Ξ /6-93P 3710 Mitchell Street Kensington H.D.

SUBJECT: Historic Area Work Permit DATE: MANMAD 18,1993

HISTORIC PRESERVATION COMMISSION STAFF REPORT

PROPOSAL: ADA Alterations

PE: FENGINGTON, AFMORT (HPG-31/4-93P) HANDFAILOG & H/G SIGNAGE NO. OF SHEETS: 2 INCLUDING THIS COVER

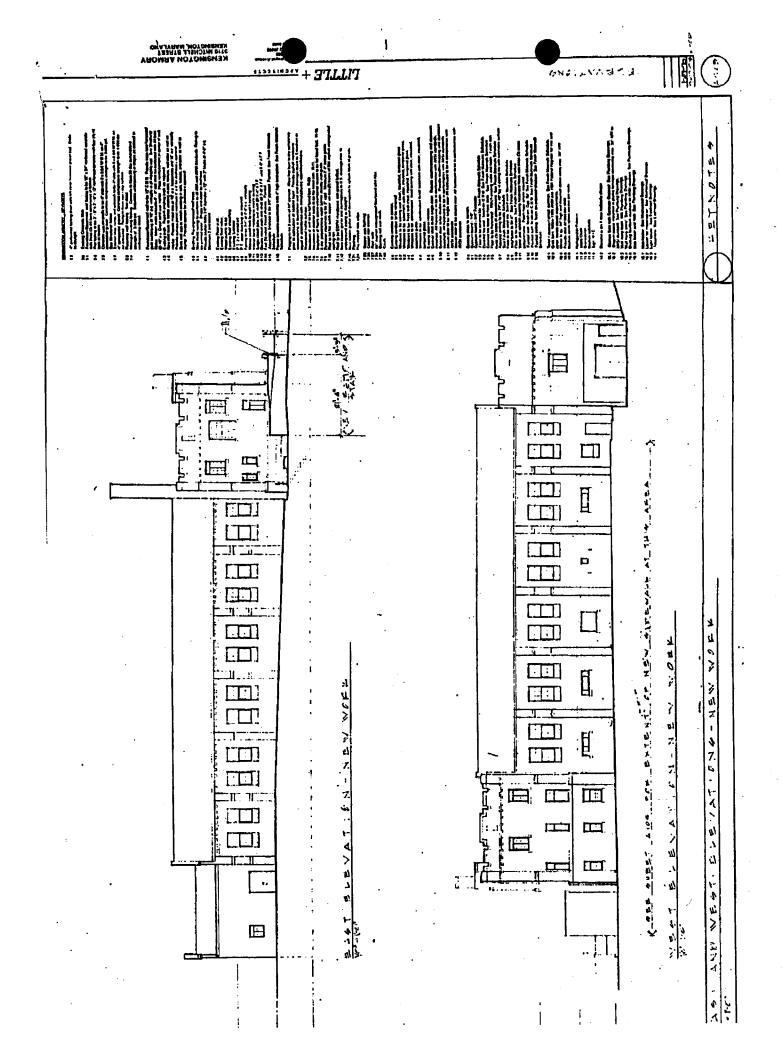
-GIGN GHAN BE C'XG"

H/C GIGNAGE HETNOTE-11.4 HC SIGNAGE TO CONFORM TO ANGI A117.1-1986 SECTION 4.28

HANDRANG TO CONFORM W/ ANGI A117.1-1980 BOTION 4.9.4

DETAIL - HANDRAIL GEOTION
